# Proposed Changes for Annex 69B

Howard Baumer, Magesh Valliappan

04-Mar-2006

# Fitted Attenuation (Amax)

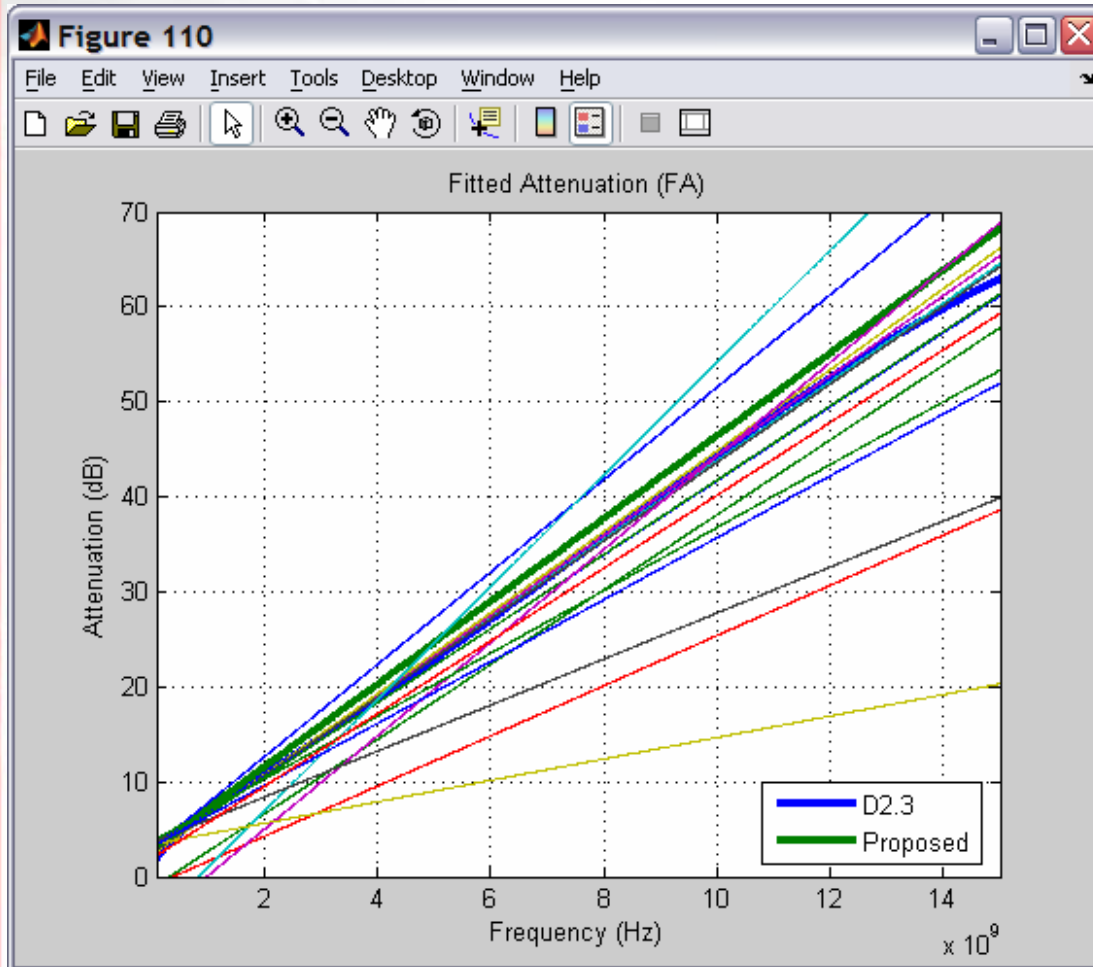
Failing Channels

$$100\text{MHz} \leq f \leq 380\text{MHz}$$

$$A(f) \geq A_{\max} = 3.18 + 3.21 \cdot 10^{-9} \cdot f$$

$$380\text{MHz} < f \leq 15\text{GHz}$$

$$A(f) \geq A_{\max} = 2.74 + 4.36 \cdot 10^{-9} \cdot f$$

# Insertion Loss (IL)

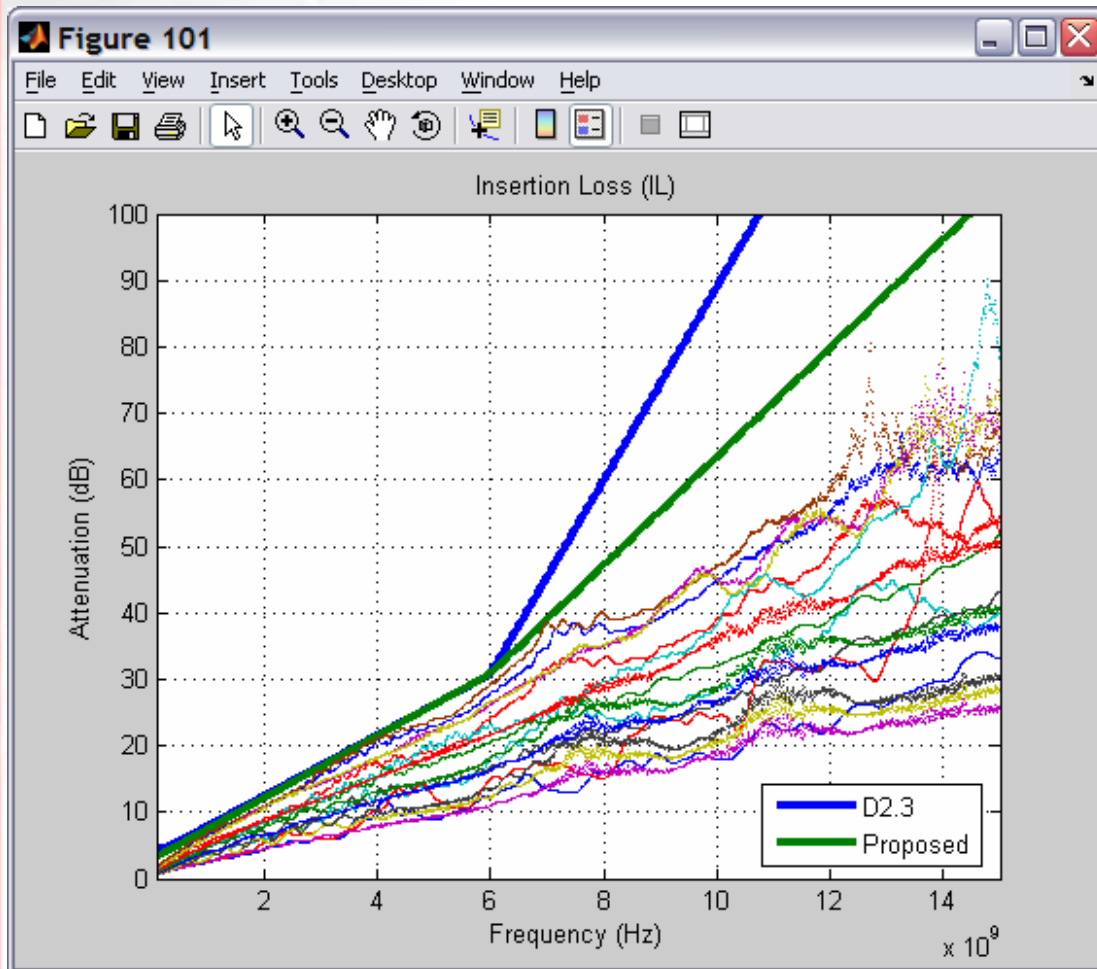
Passing Channels

$$50\text{MHz} \leq f \leq 6\text{GHz}$$

$$IL(f) \leq A_{\max} + 0.8 + 2.65 \cdot 10^{-10} \cdot f$$

$$6\text{GHz} < f \leq 15\text{GHz}$$

$$IL(f) \leq A_{\max} + 0.8 + 2.65 \cdot 10^{-10} \cdot f + 3.5 \cdot 10^{-9} \cdot (f - 6\text{GHz})$$

# Insertion Loss (IL)

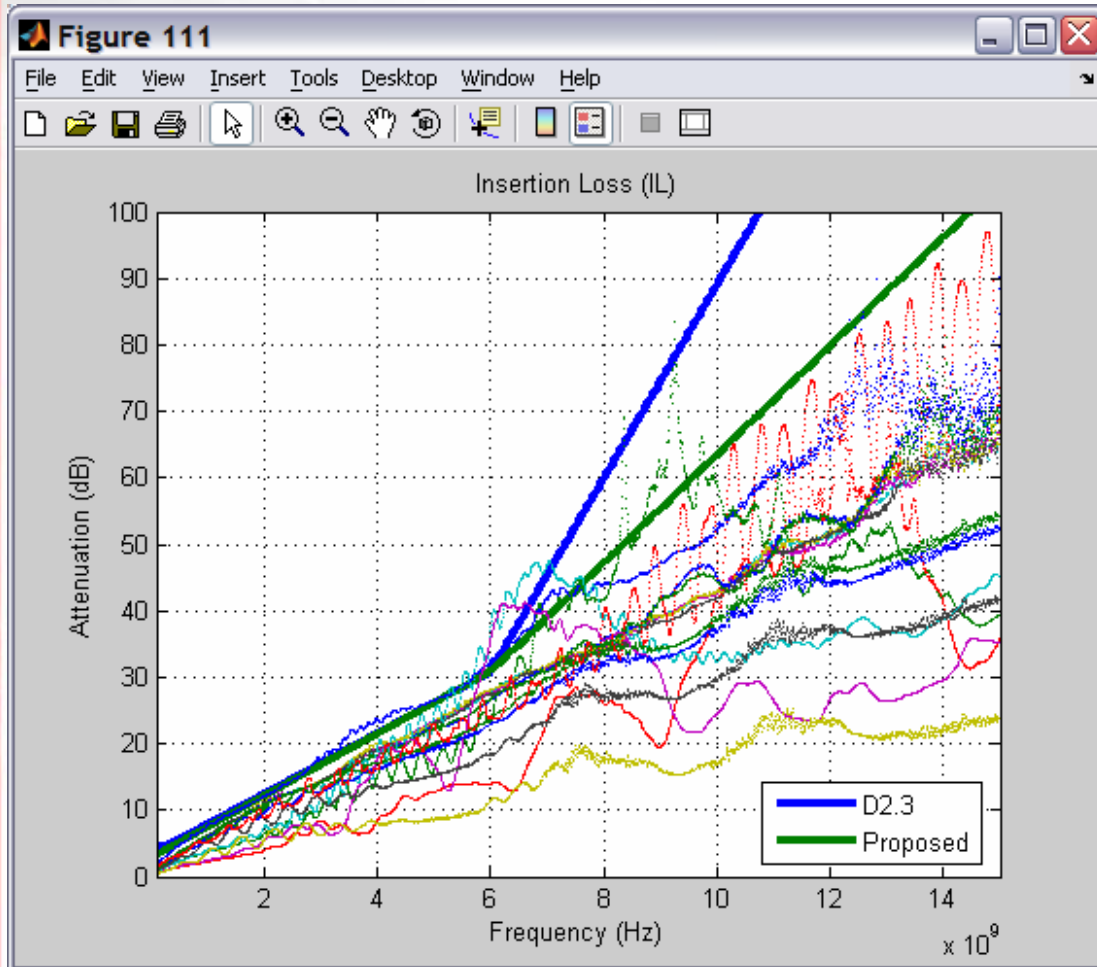
Failing Channels

$$50\text{MHz} \leq f \leq 6\text{GHz}$$

$$IL(f) \leq A_{\max} + 0.8 + 2.65 \cdot 10^{-10} \cdot f$$

$$6\text{GHz} < f \leq 15\text{GHz}$$

$$IL(f) \leq A_{\max} + 0.8 + 2.65 \cdot 10^{-10} \cdot f + 3.5 \cdot 10^{-9} \cdot (f - 6\text{GHz})$$

# Insertion Loss Deviation (ILD)

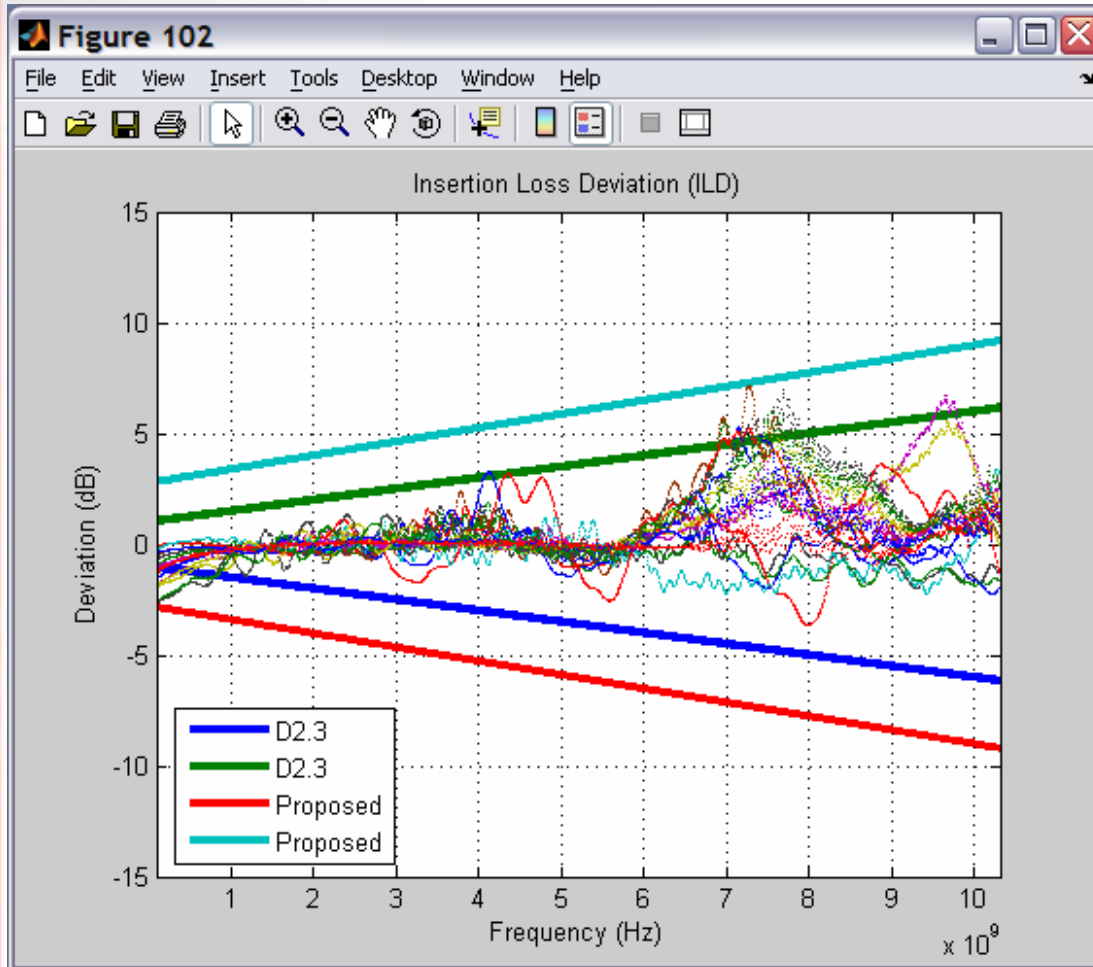
Passing Channels

$$100\text{MHz} \leq f \leq 10.3125\text{GHz}$$
$$-2.77 - 4.36 \cdot 10^{-10} \cdot f \leq \text{ILD}(f)$$
$$\text{ILD}(f) \leq 2.77 + 4.36 \cdot 10^{-10} \cdot f$$

# Insertion Loss Deviation (ILD)

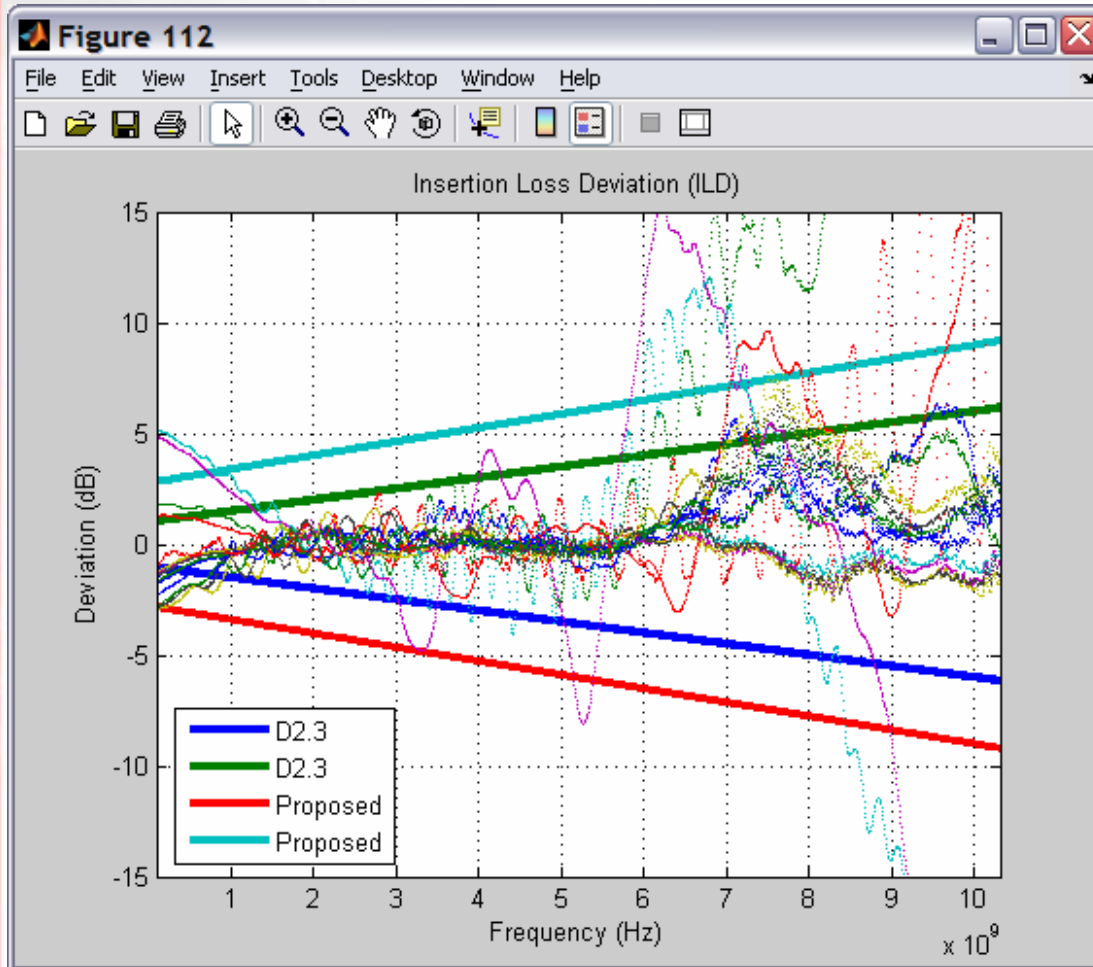
Failing Channels

$$100\text{MHz} \leq f \leq 10.3125\text{GHz}$$
$$-2.77 - 4.36 \cdot 10^{-10} \cdot f \leq \text{ILD}(f)$$
$$\text{ILD}(f) \leq 2.77 + 4.36 \cdot 10^{-10} \cdot f$$

# Return Loss (RL)

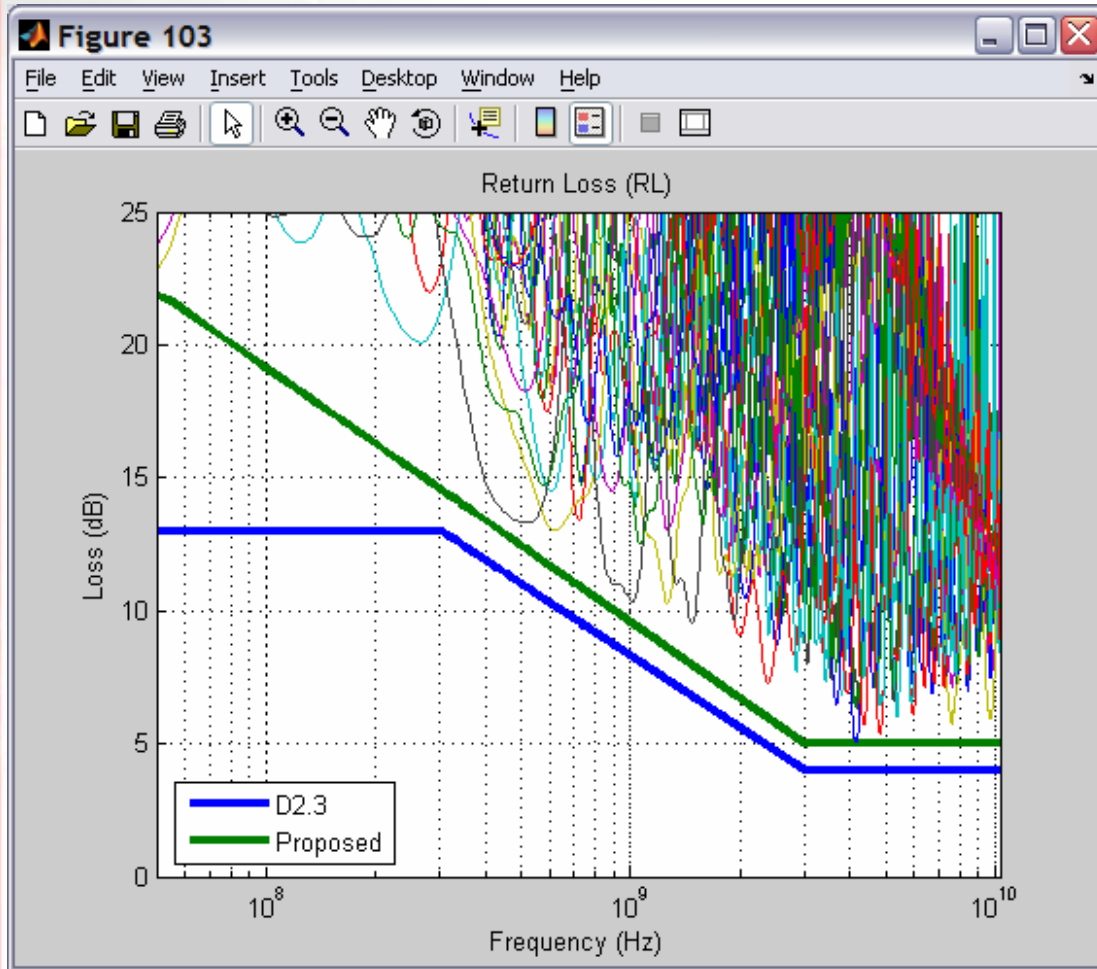
Passing Channels

$50\text{MHz} \leq f < 3\text{GHz}$

$$\text{RL}(f) \geq 22 + 9.56 \cdot \log_{10} \left( \frac{f}{50\text{MHz}} \right)$$

$3\text{GHz} \leq f \leq 10.3125\text{GHz}$

$$\text{RL}(f) \geq 5$$

# Return Loss (RL)

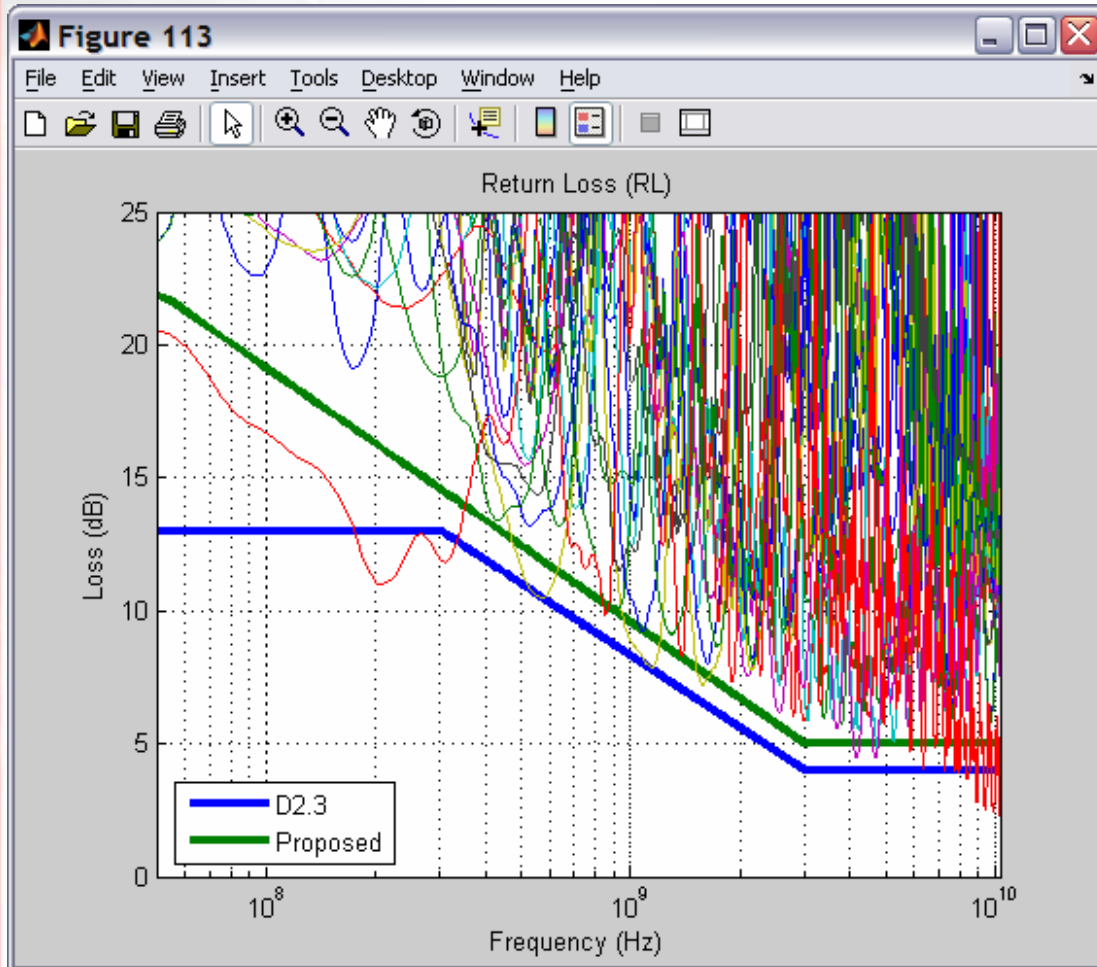
Failing Channels

$$50\text{MHz} \leq f < 3\text{GHz}$$

$$\text{RL}(f) \geq 22 + 9.56 \cdot \log_{10} \left( \frac{f}{50\text{MHz}} \right)$$

$$3\text{GHz} \leq f \leq 10.3125\text{GHz}$$

$$\text{RL}(f) \geq 5$$

# Fitted Insertion Loss to Crosstalk Ratio (ICR<sub>fit</sub>)

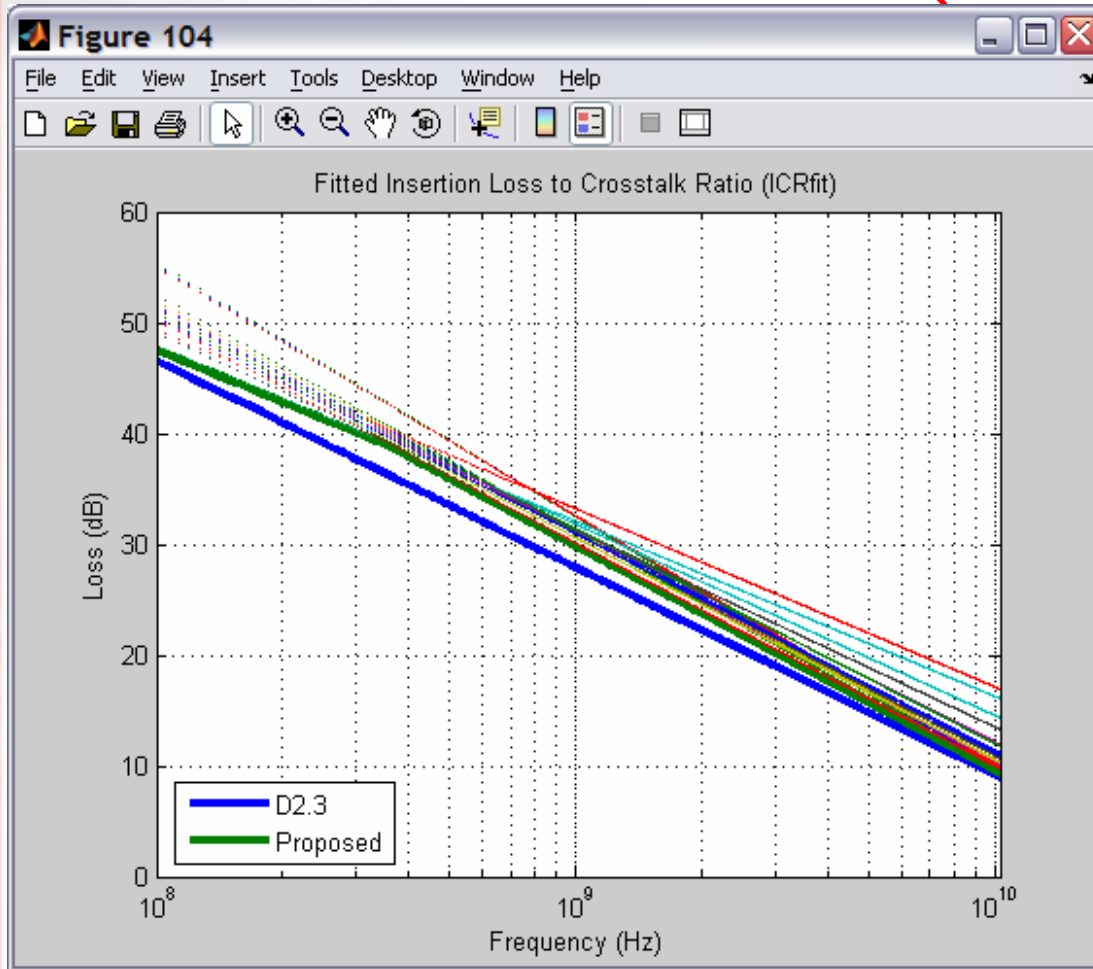
Passing Channels

$100\text{MHz} \leq f < 350\text{MHz}$

$$\text{ICR}_{\text{fit}}(f) \geq 47 - 15.62 \cdot \log_{10} \left( \frac{f}{100\text{MHz}} \right)$$

$350\text{MHz} \leq f \leq 10.3125\text{GHz}$

$$\text{ICR}_{\text{fit}}(f) \geq 39 - 20.21 \cdot \log_{10} \left( \frac{f}{350\text{MHz}} \right)$$

# Fitted Insertion Loss to Crosstalk Ratio ( $ICR_{fit}$ )

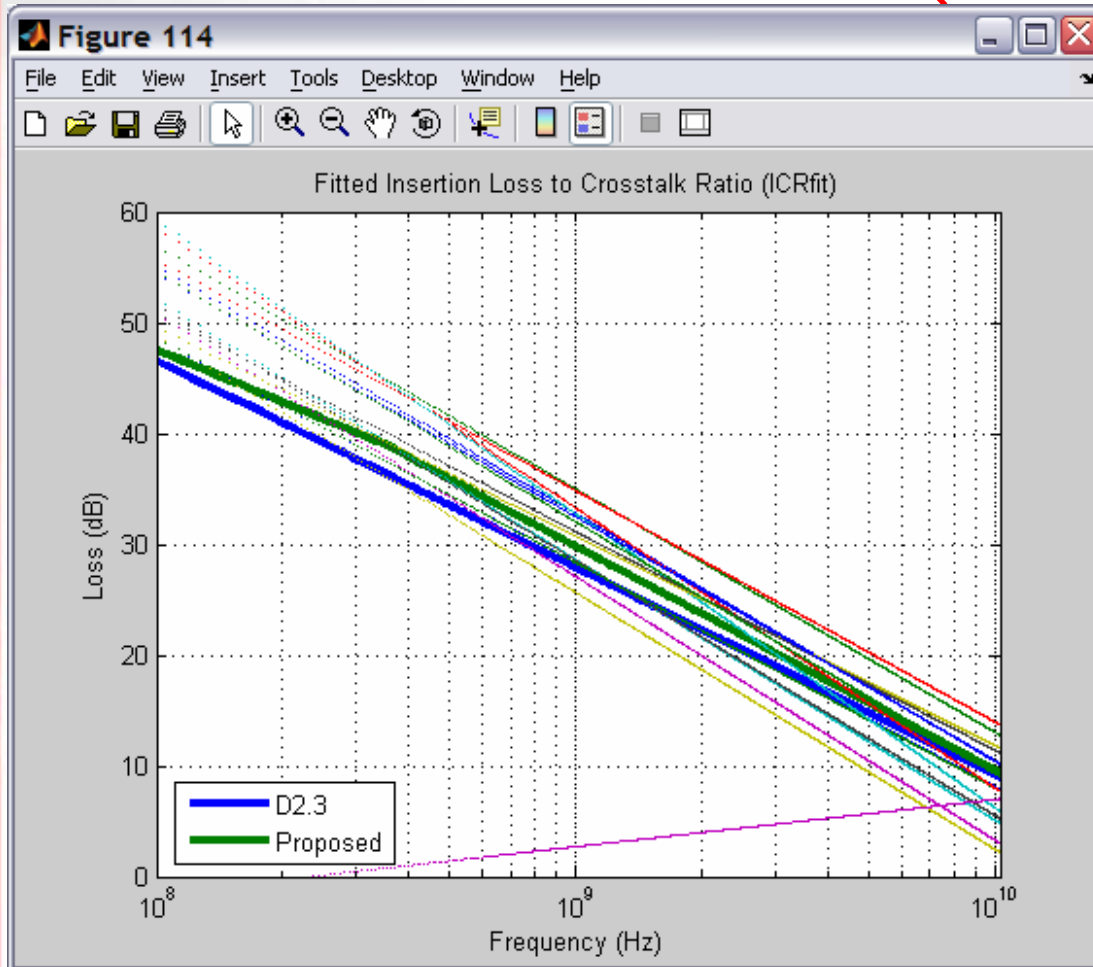
Failing Channels

$100\text{MHz} \leq f < 350\text{MHz}$

$$ICR_{fit}(f) \geq 47 - 15.62 \cdot \log_{10} \left( \frac{f}{100\text{MHz}} \right)$$

$350\text{MHz} \leq f \leq 10.3125\text{GHz}$

$$ICR_{fit}(f) \geq 39 - 20.21 \cdot \log_{10} \left( \frac{f}{350\text{MHz}} \right)$$

# KX4 vs. CX4 (IL)

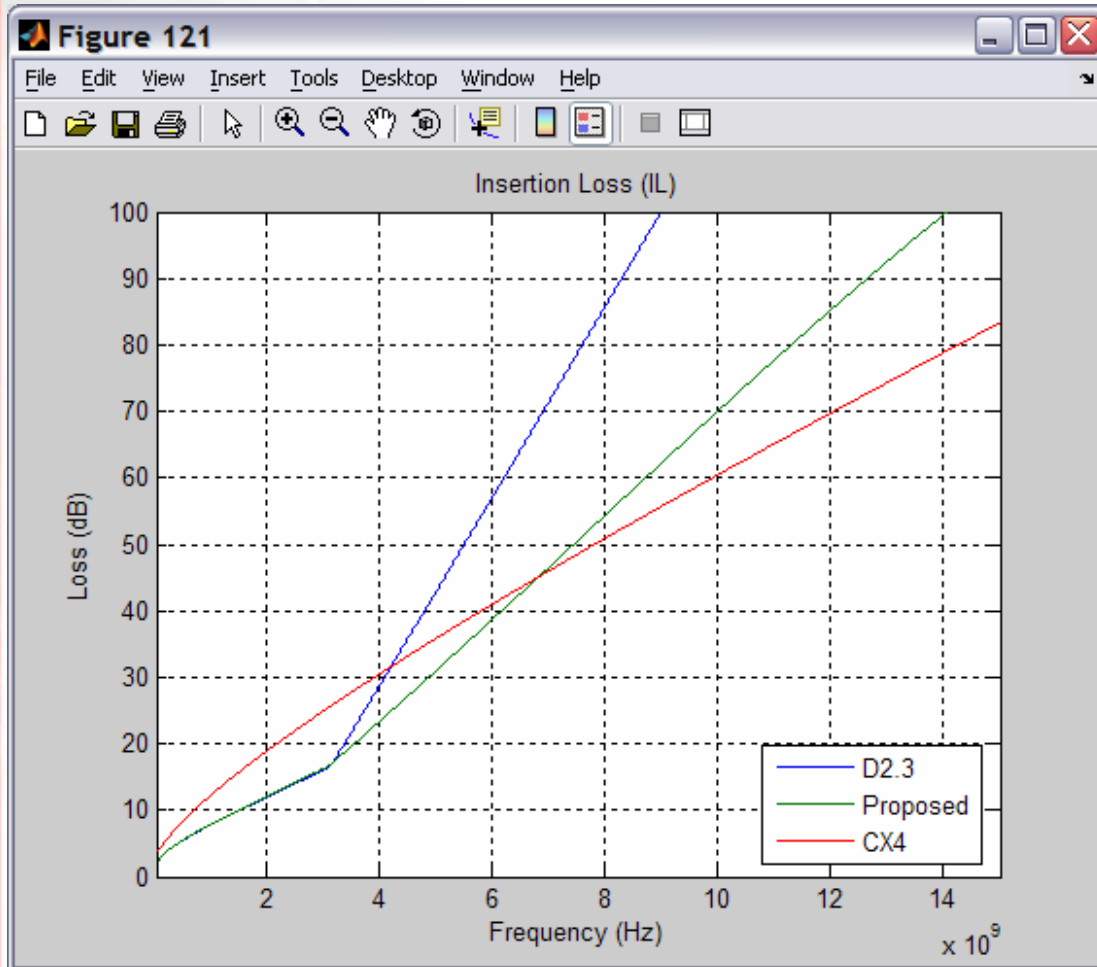
- 10GBASE-CX4 IL more than proposed 10GBASE-KX4 IL in frequency band of interest, 100MHz – 2000MHz
